HYDROGEOLOGY OF NATIONS DRAW AREA: ANALYSIS OF POTENTIAL IMPACTS ON ZUNI SALT LAKE FROM PROPOSED FENCE LAKE MINE GROUNDWATER DIVERSIONS

Prepared for:
The Zuni Tribe

Glorieta Geoscience, Inc.
P.O. Box 5727
Santa Fe, NM 87502
(505) 983-5446

May 29, 2001

Figure 19. Drawdown plot from 500 minute pumping test of FL-36(OB1)

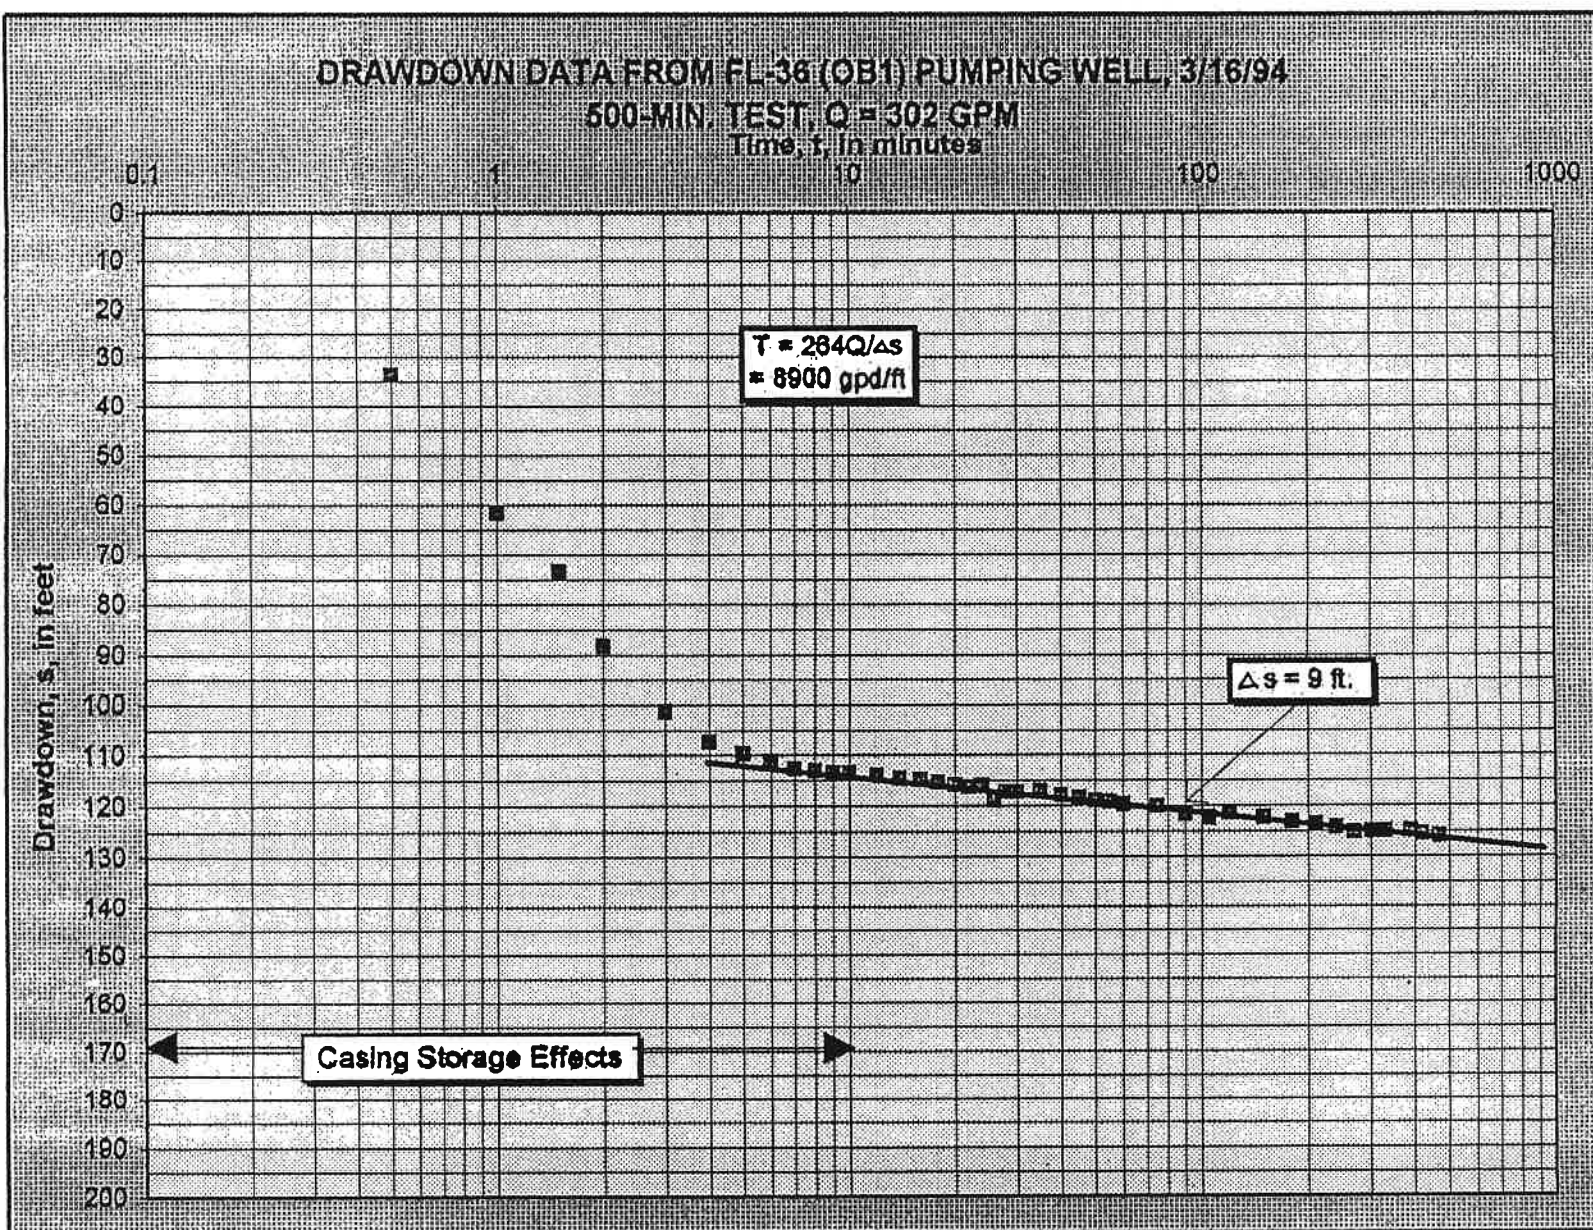
SRP conducted a 500-minute test on FL-36 (OB1) at an average discharge rate (Q) of 302 gpm on March 16, 1994. A semi logarithmic plot of drawdown data from the pumping well indicates that the data fit a Cooper-Jacob (1946) straight line solution very well for the time period after which casing storage effects are negligible (Figure 19). Casing storage effects were calculated using the methodology described in Driscoll (1986, p.232-234). An example of the calculation of casing storage effects is presented in Appendix B for the December, 1994 50-hour pumping test.

The inflection point observed in the drawdown plot from the pumping well between three and ten minutes (Figure 19) is related to casing storage effects, and is not an indication of a leaky aquifer response, as has been asserted by SRP. SRP's use of the pumping well to obtain a curve match for a leaky aquifer solution is a highly questionable and self-serving methodology. The reference cited by SRP for the leaky aquifer solution (Hall, 1996) states unequivocally, on p. 253, that "If time vs. drawdown data is plotted from an observation well on a semi-log graph, the slope is similar to the slope obtained from the Jacob plot in a confined aquifer, except where the drawdown levels off due to leakage through the leaky confining layer."

Figure 20. Drawdown plot of observation well during 500 minute pumping test of FL-36(OB-1).

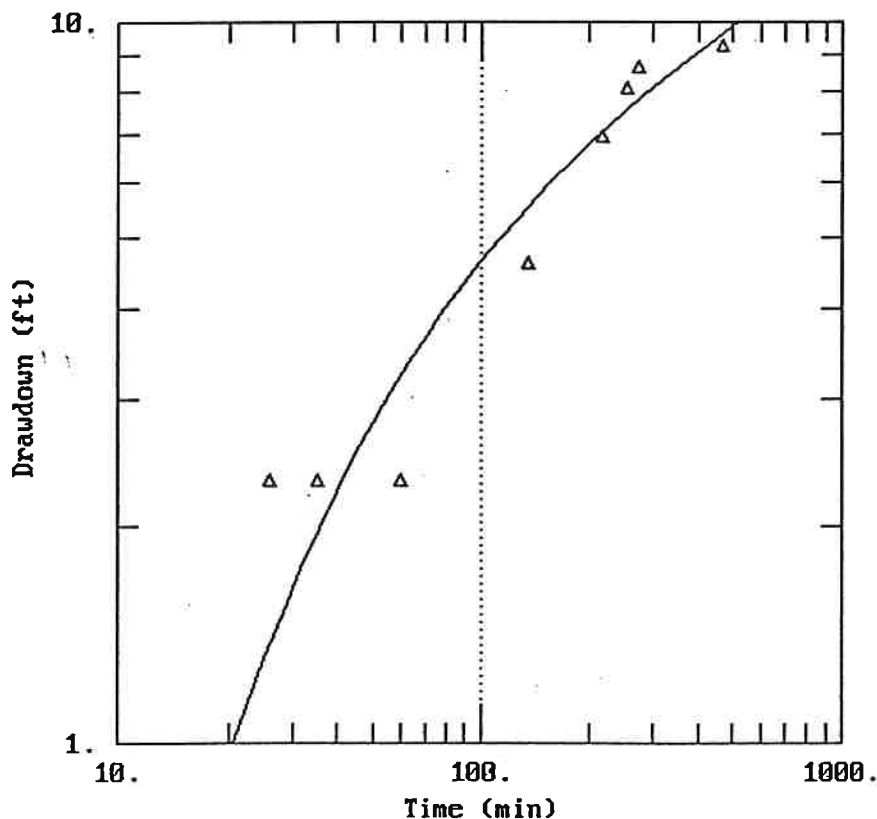
Drawdown data were collected periodically from observation well FL-36 during the test. However, the apparent resolution of the transducer readings of 1 psi during the first 200+ minutes of the test (allowing for an unacceptably high incremental change of 2.31 feet of drawdown) and the relatively few drawdown measurements taken (9 measurements total after the start of pumping; see Appendix B) did not produce usable data for aquifer analysis (Figure 20).

Figure 21. Drawdown plot of observation well (FL-36) during 50 hour pumping test of FL-36(OB1)

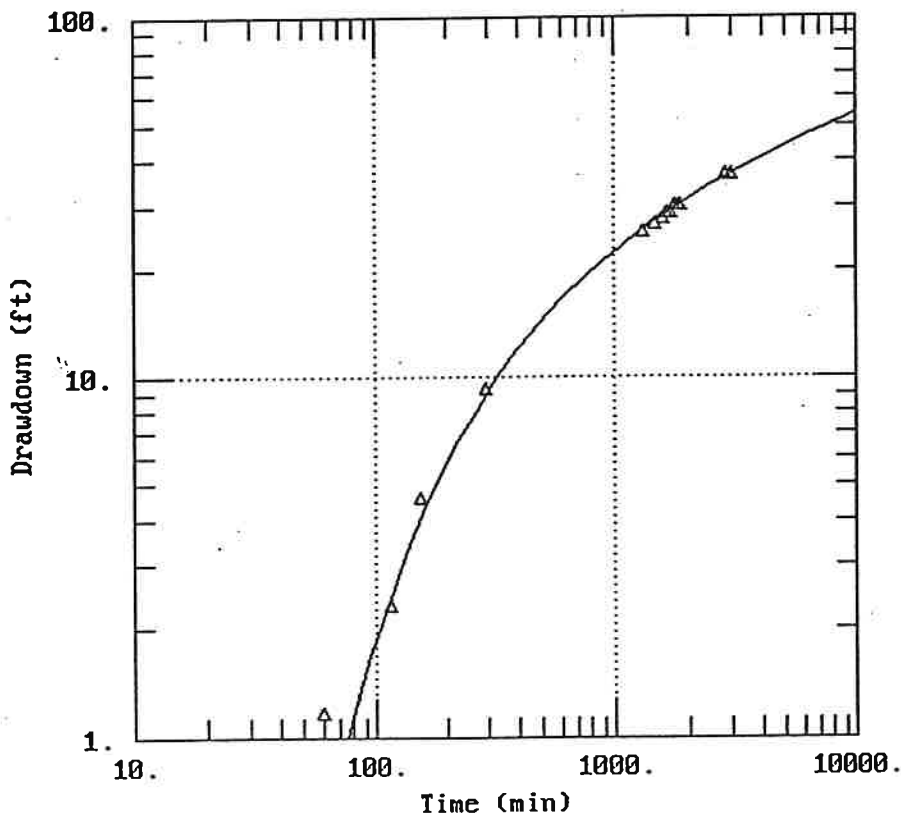
Drawdown data were also collected periodically from observation well FL-36 during the 50-hour test (described below on pages 43 and 44); however, drawdown data were not collected between 295 minutes (when drawdown (s) was 9.24 feet) and 1315 minutes (when s was 25.41 feet) (Figure 21; Appendix B). With the entire middle part of the curve missing from the observation well data, a variety of different curve matches will fit the late-time data. GGI obtained a good Theis curve match to the late time data and therefore contends that a Theis analysis is most appropriate based on a variety of criteria including: (1) the use of proper methodology for hydrologic analysis; (2) selection of the method of analysis that most closely represents the geologic and hydrologic conditions in an area; and, (3) comparison with drawdown data from the pumping well. According to United States Geological Survey (USGS) Water Supply Paper 2220 (Heath, 1983), when geologic and hydrologic conditions in an area are not well known, "the common practice is to prepare a data plot of s versus t on logarithmic paper and match it with the Theis type curve. If the data closely match the type curve, the values of T and S determined by using the Theis equation should be reliable." GGI's examination of outcrops exposing the shale beds which overlie the main body of the Dakota Sandstone indicate that, contrary to assertions made by SRP, shale beds in the study area are not extensively fractured, and that fractures which extend into shale units from overlying sandstone beds are discontinuous or closed. Finally, drawdown data from the pumping well exhibit a steepening in the curve (e.g. greater than predicted drawdown) after 500 minutes. A leaky aquifer response should exhibit the opposite effect, or a flattening in the curve and less than predicted drawdown for the late-time data. The method of analysis that most closely represents the geologic and hydrologic conditions in the area is therefore a Theis analysis based on a confined aquifer model. **The pumping test data from the March and December, 1994 Dakota aquifer pumping tests exhibit no evidence of a leaky aquifer response.** The BIA Report (King Engineering, 2001) agrees with this conclusion.

Figure 22. Drawdown plot from 3000 minute pumping test of FL-36(OB1)

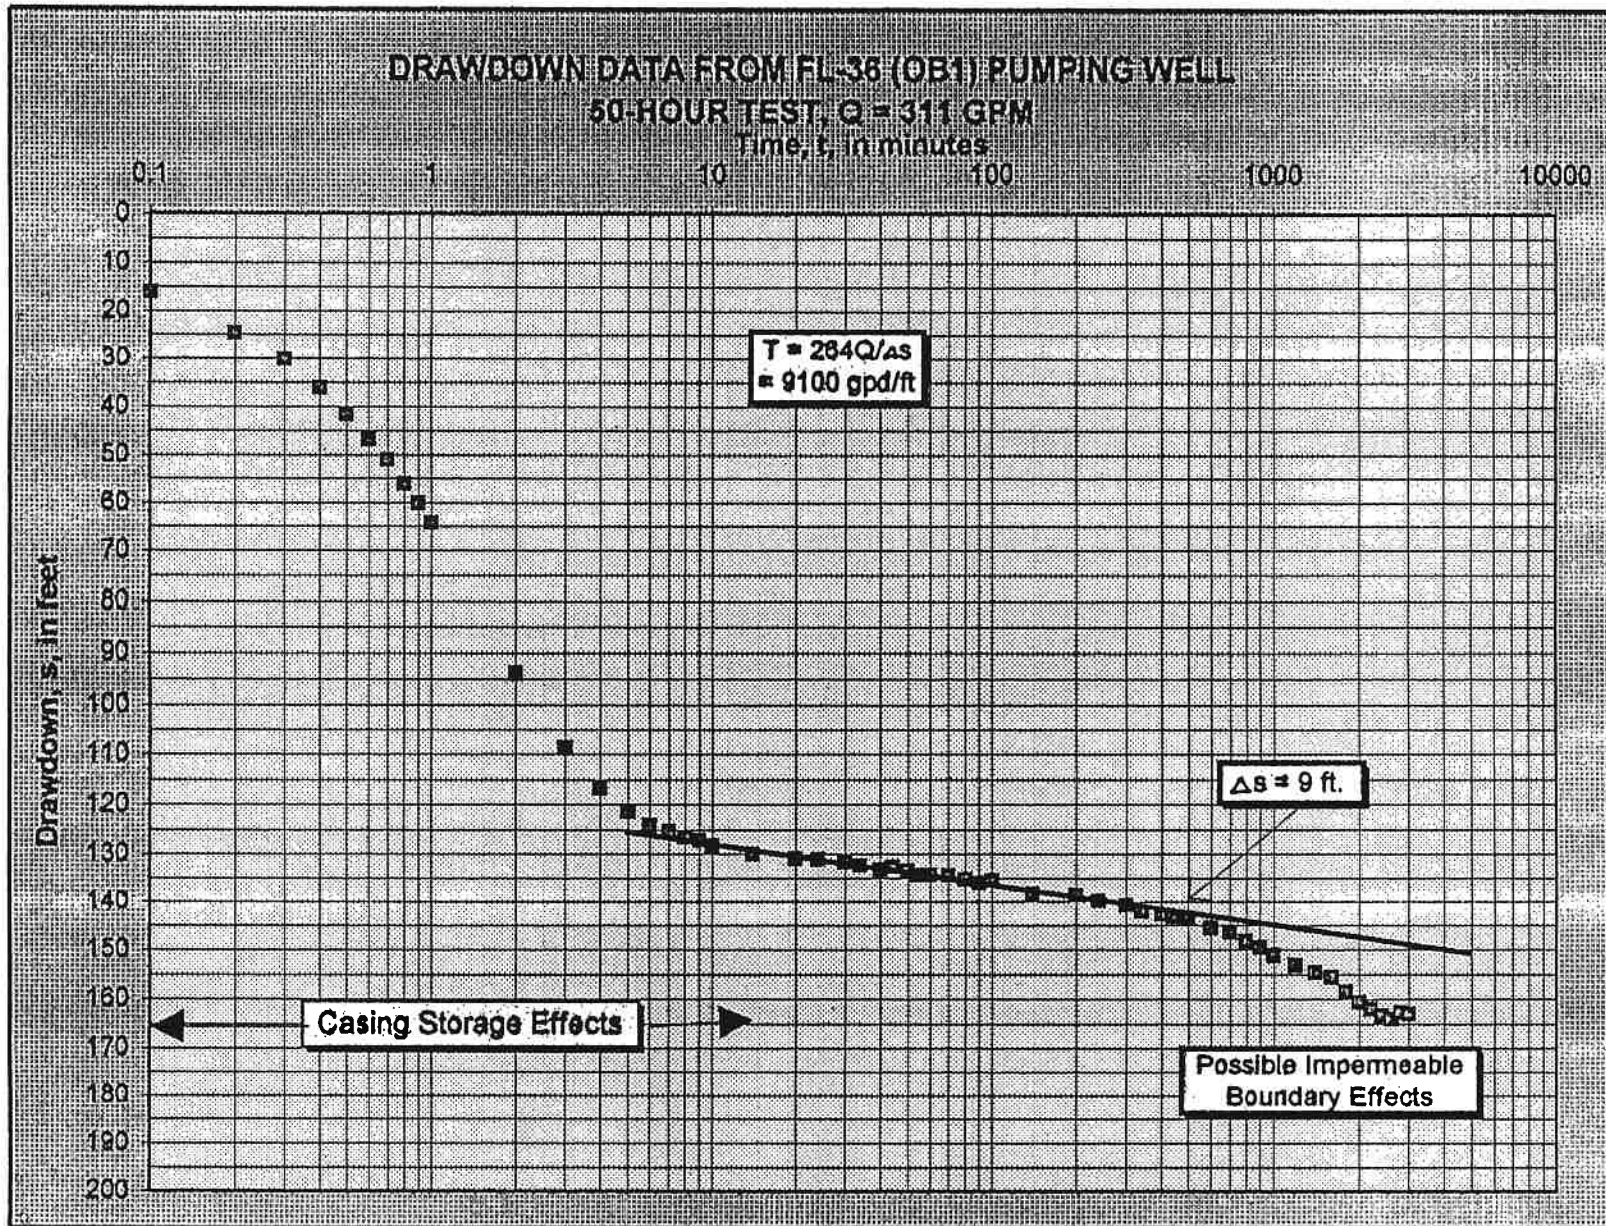
the pumping well indicates that the data fit a Cooper-Jacob (1946) straight-line solution very well for the time period between 10 and 500 minutes (Figure 22). This represents the time period after which casing storage effects are negligible and prior to possible impermeable boundary effects (Figure 19). GGI interprets steepening of the drawdown curve after 500 minutes to be the result of an impermeable boundary representing the lateral extent of the highly fractured Dakota Sandstone aquifer within Nations Draw. Calculations based on the drawdown curve (using an S of 6.3×10^{-4} , $t = 800$ min. (0.6 day), and the early-time T of 9000 gpd/ft), and solving for radial distance r_o , using the equation:

Figure D1. Modeled drawdown in feet after 40 years of pumping 85 gpm from the Dakota Sandstone aquifer.

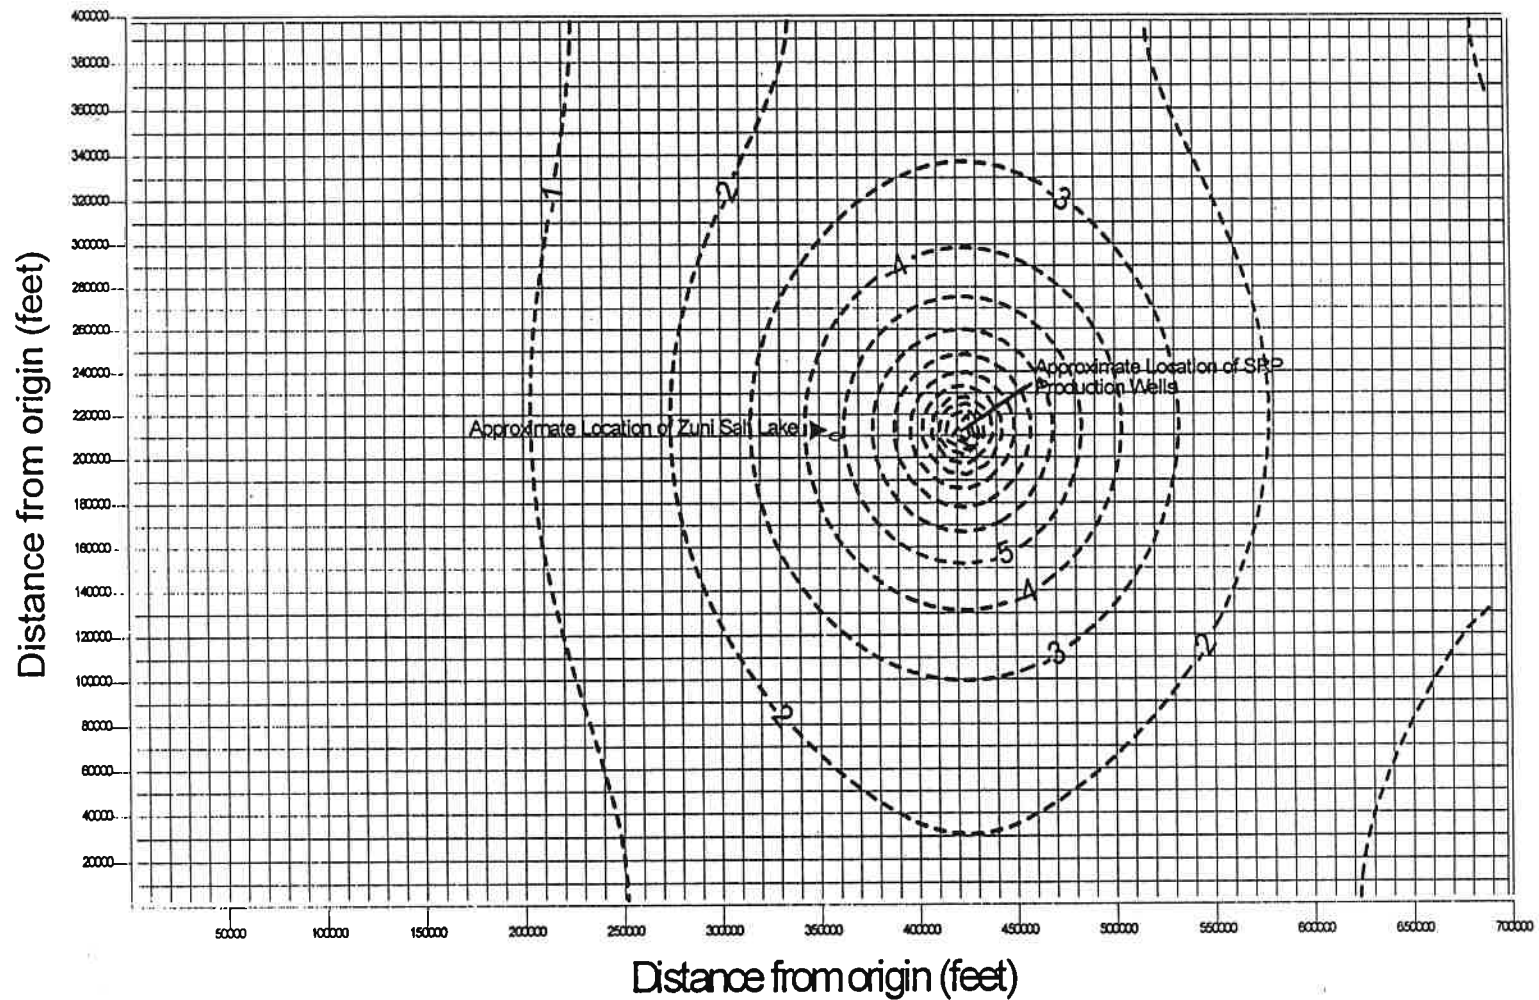
In 1997, GGI developed a simplified numerical model to predict drawdown at Zuni Salt Lake resulting from SRP's proposed mine diversion. GGI ran a one-layer, two dimensional groundwater flow model using the U.S. Geological Survey's MODFLOW code. The model incorporates a uniform value for transmissivity of 700 ft²/day (5200 gpd/ft) and storage coefficient of 0.00049 for the Dakota Sandstone aquifer. Boundaries of the model were chosen so that they would lie beyond the radius of zero drawdown, limiting boundary effects, and making the model conservative. These aquifer coefficients are derived from Dakota Sandstone pumping tests (see Appendix B) and are consistent with values used by Myers (1992) and Core (1996). GGI ran the model for 40 years at the discharge rate of 85 gpm (137 acre-ft/yr), the proposed mine discharge. Estimated drawdown at Zuni Salt Lake resulting from pumping 85 gpm for 40 years was between 4 and 5 feet (Figure D-1). Since Zuni Salt Lake is usually less than 4 feet deep (Myers, 1992), pumping 85 gpm from the Dakota aquifer for 40 years at the proposed Fence Lake Coal Mine will dramatically affect the water balance and water levels in Zuni Salt Lake.
